Flight Procedure Tracking Form		Action: FLIGHT CHECK	Task Type: IAP	Date Open: 02/05/2016	Task #: 2015121713110301002	Request #: 20151217131103
Procedure: ILS OR LOC RWY 7R AMDT 4			Airport ID: PANC	Airport: TED STEVENS ANCHORAGE INTL		Reimbursable #: NO
City: ANCHORAGE	ST: AK	GPS #:	Estimated Chart Date: 10/10/2019			FICO #:
Fac ID: ANC		Fac. Type: ILS			Specialist: TAYLOR GIBSON	
Procedure Review						
	Rec'd	Rel'd	Full Name	Comments		
Lead:	03/12/2019	07/02/2019	CHRIS MCCARTHY	QUALITY		
QA:	07/02/2019			26		
Liaison:				CHECKED		
Procedure Comments: ENROUTE-NON Remark Type: INFORMATION						
APPROVAL LETTER REQUESTED FOR BLOCK ALTITUDE IN INTERMEDIATE SEGMENT.						
PENDING AIRPORT AND NAVAID DATA USED.						
CANCELS NOTAM FDC 9/0905.						
HARD DATE DUE TO AMENDMENTS COINCIDING WITH 15/33 RWY EXTENSION.						
CONTACT DAVE DANNER 405-954-5077.

ILS RWY 7R (CAT II & III)
TED STEVENS ANCHORAGE INTL (ANC) (PANC)

Request approval for the addition of a block altitude of 1600-3000 in the intermediate segments for ILS or LOC RWY 7R, ILS RWY 7R SA CAT I and ILS RWY 7R CAT II/III. Ted Stevens Anchorage Intl, Anchorage, AK, (PANC).

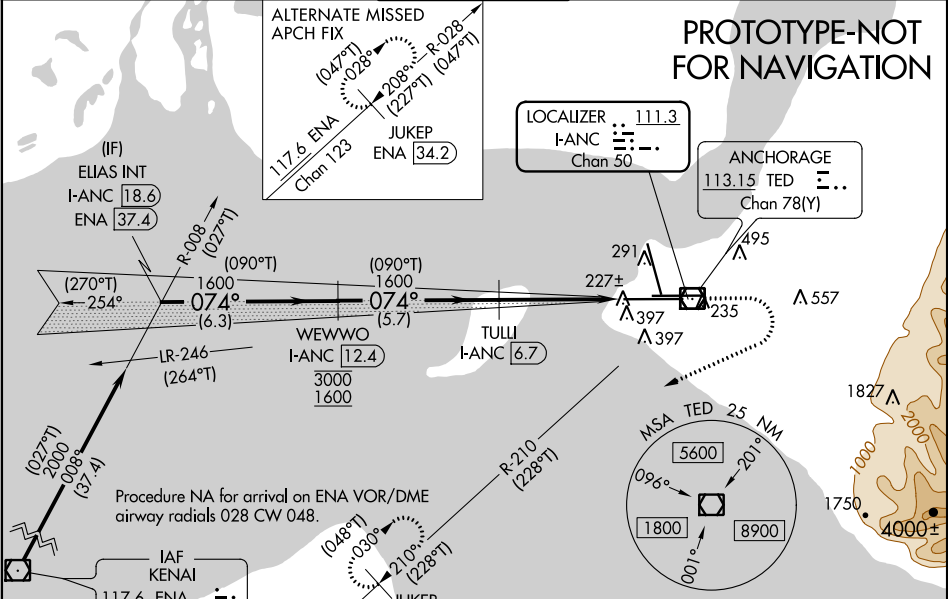
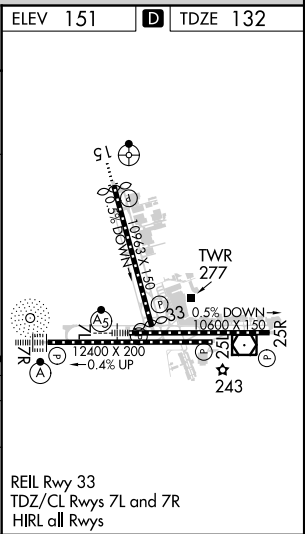
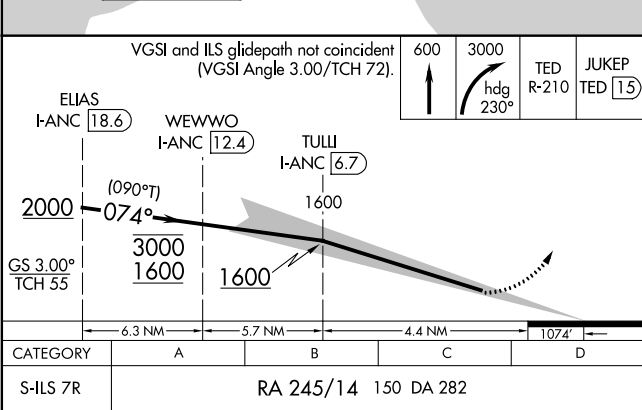
DME required.	ALSIF-2	MISSED APPROACH: Climb to 600 then climbing right turn to 3000 on heading 230° and on TED VOR/DME R-210 to JUKEP/TED 15 DME and hold. (TACAN aircraft climb to 600 then climbing right turn to 3000 on heading 230° and on EDF TACAN R-210 to JUKEP/EDF 22.6 DME and hold).
▼ Rwy 7L threshold 6140 feet east of Rwy 7R threshold. ▲ CAT II: RVR 1000 authorized with specific OPSPEC, MSPEC, or LOA approval and use of autoland or HUD to touchdown.	ALSIF-2

ILS RWY 7R (CAT II & III)

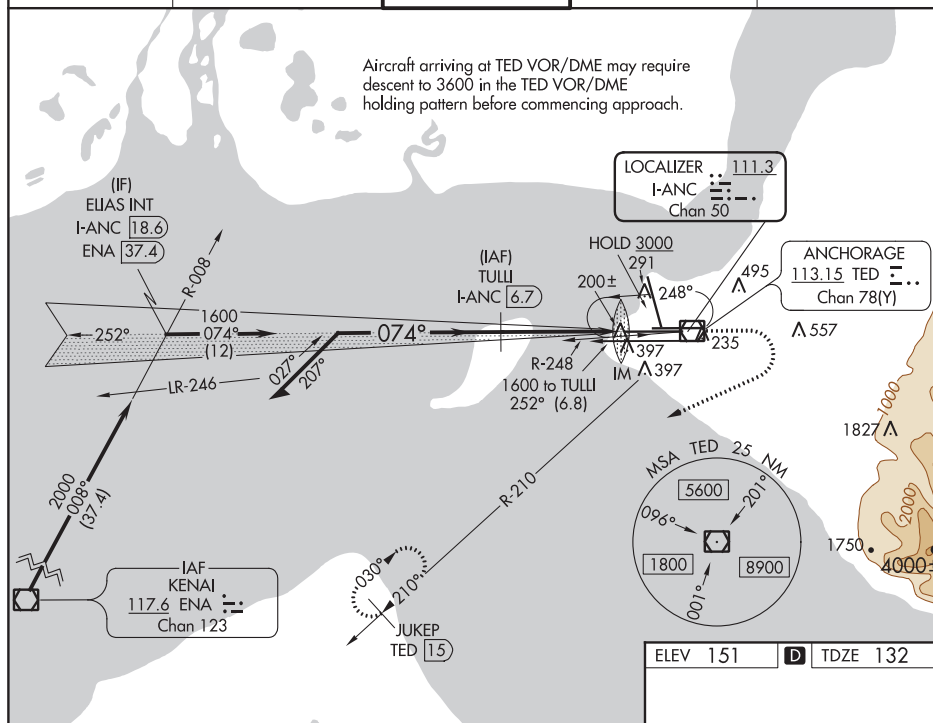
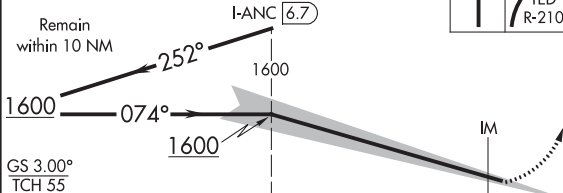
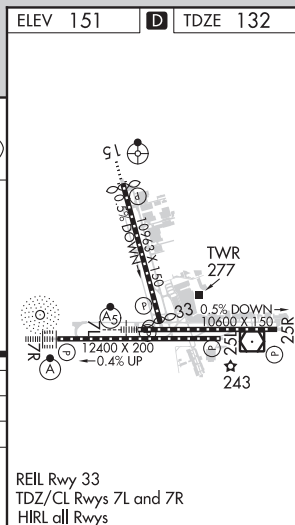
The current intermediate segment does not contain a block altitude. Request to establish a block altitude of 1600-3000 between the intermediate fix (ELIAS) and a new intermediate stepdown fix (WEWWO).

PANC ILS RWY 7R CAT II/III
MA OBS EVAL
EVALUATED OBSTACLES

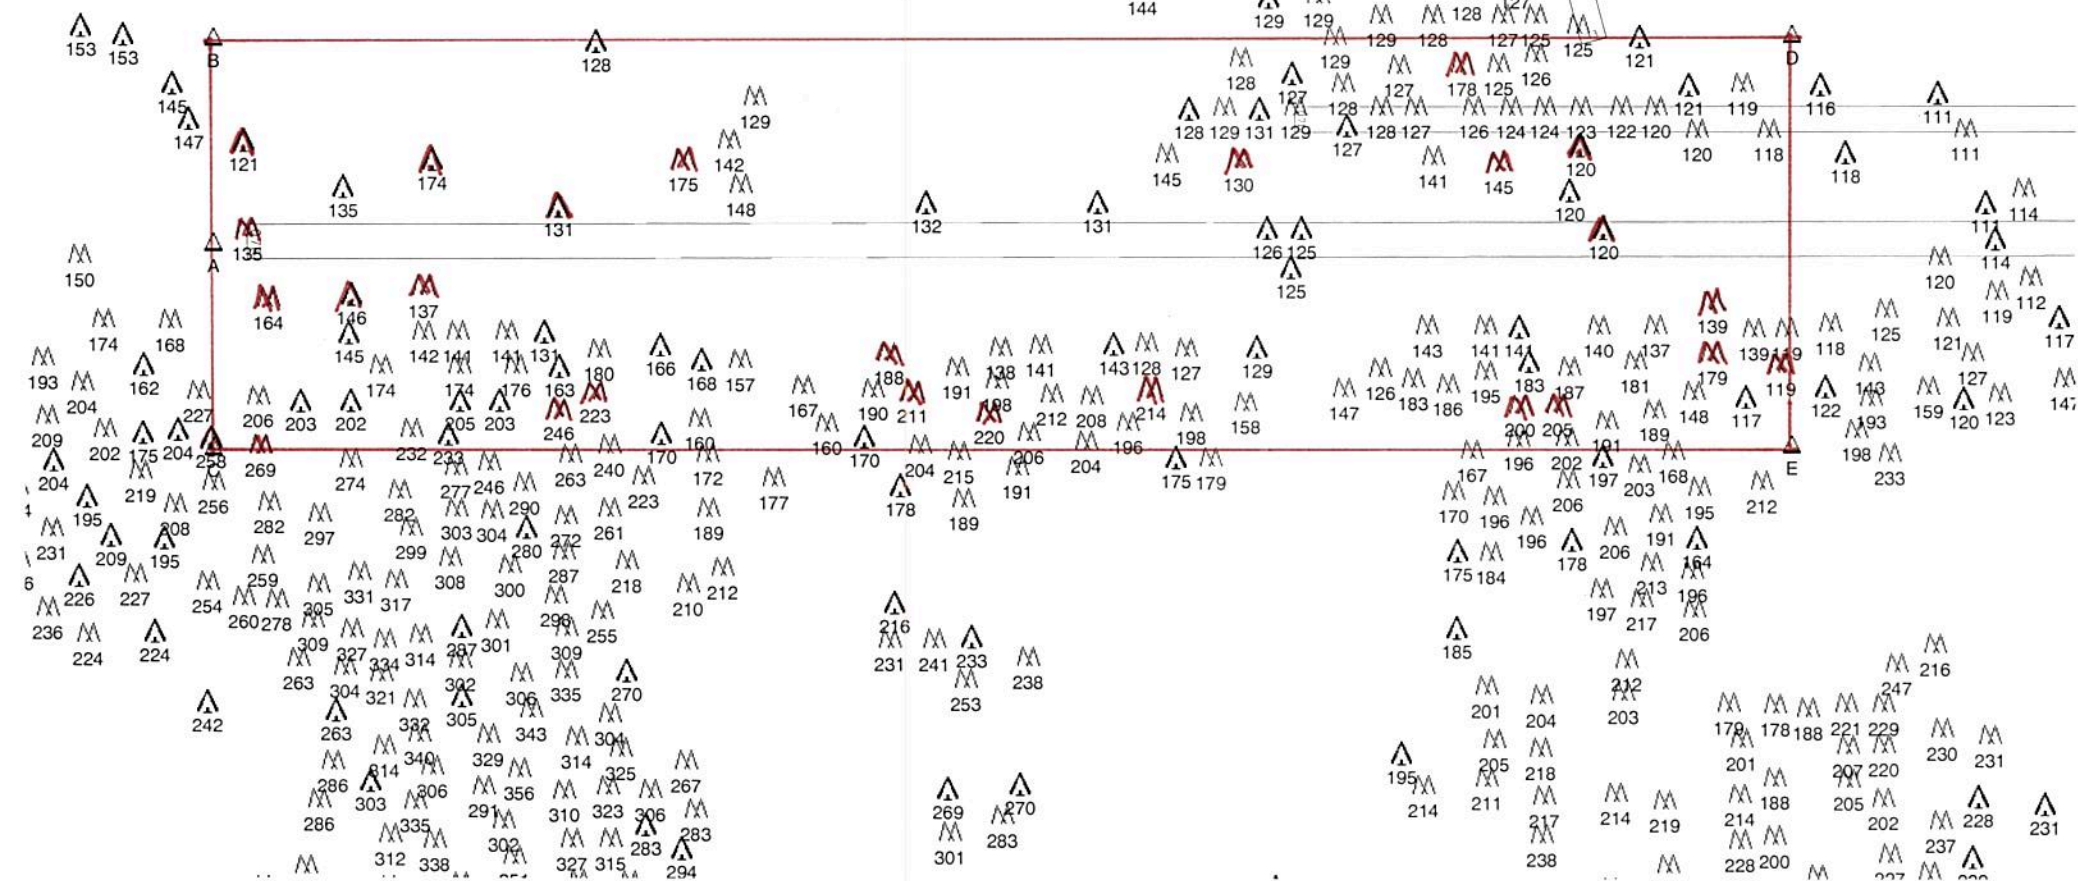
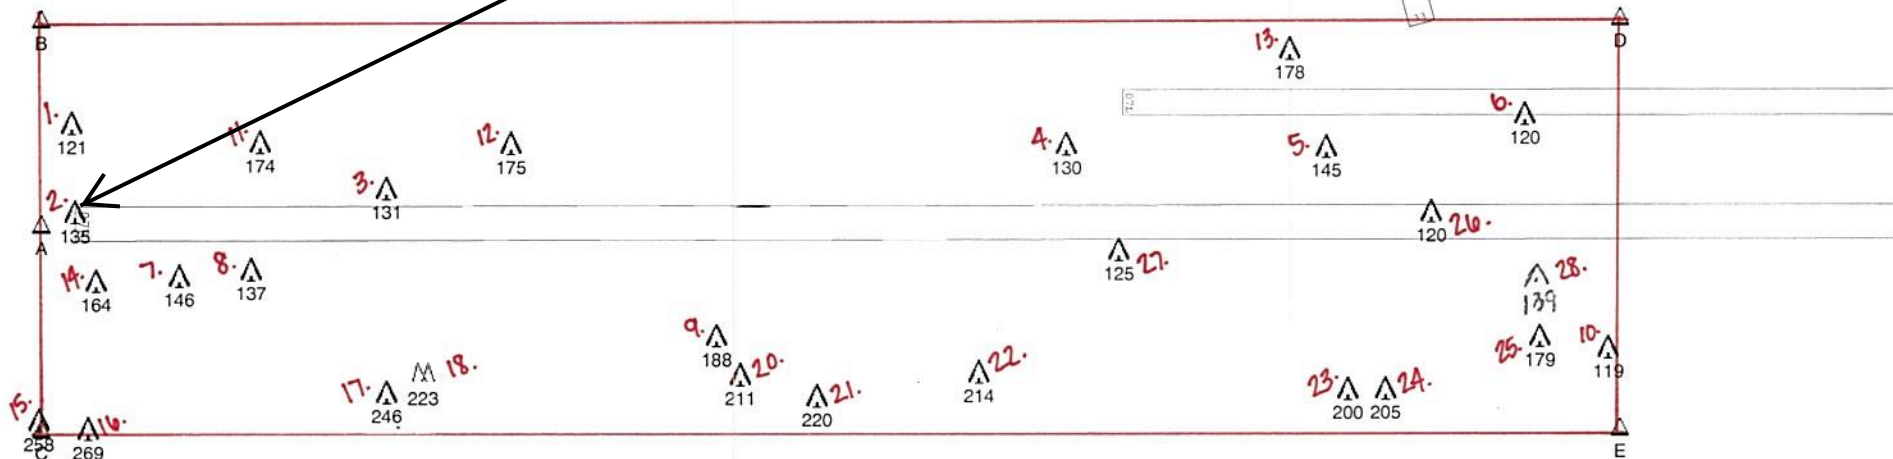
2. 135' NAVAID
(02-0205970)
611004.13N/1500234.42W
3 foot penetration, FRANGIBLE
See MEMO 190 for further clarification
